LATEST REVISION DATE 04-12	 APPROVED BY BRIDGE ENGINEER	 STANDARD DESIGN - 24' ROADWAY, THREE SPAN BRIDGE PRETENSIONED PRESTRESSED CONCRETE BEAM BRIDGES DECEMBER, 2006	
		ABUTMENT BACKFILL DETAILS A & B BEAMS - SKewed	H24-82-06

SKewed ABUTMENT PLAN WITHOUT WING EXTENSIONS
(SKewed LEFT AHEAD SHOWN, SKewed RIGHT AHEAD SIMILAR)

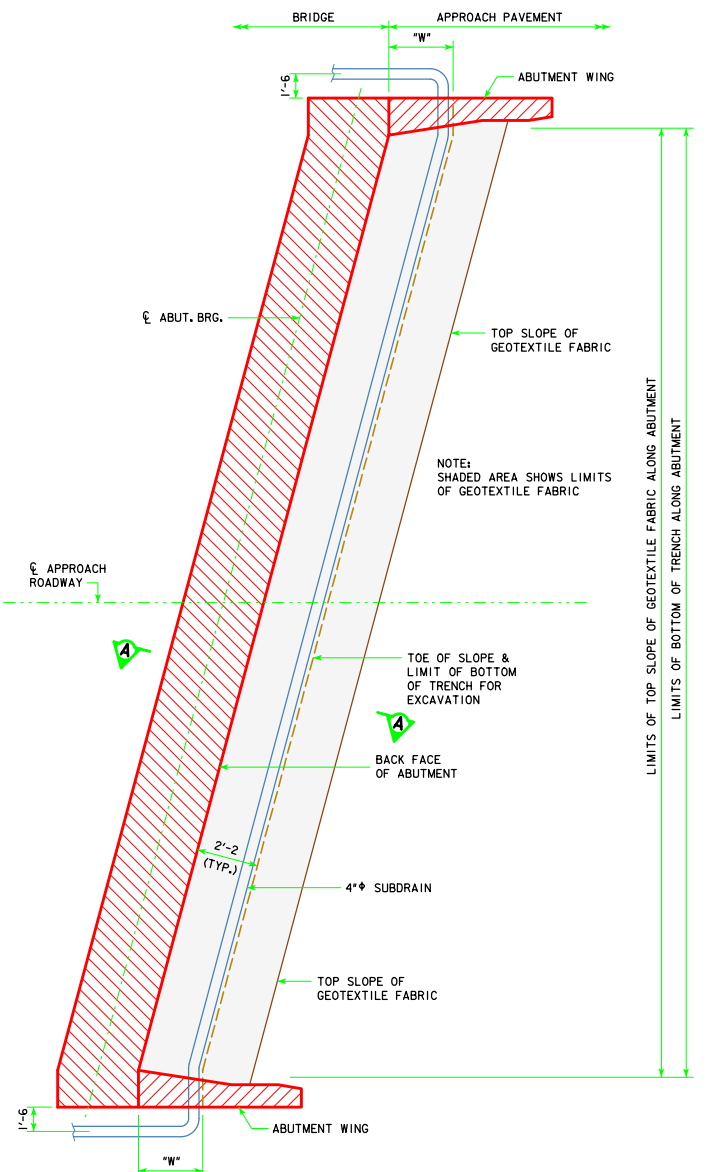
REVISED 04-12 - EXCAVATION LIMIT ON THE FRONT FACE OF THE ABUTMENT WAS CHANGED TO A 3'-0" LIMIT. THE APPROACH FILL WAS IDENTIFIED AS THE GRADING SURFACE.
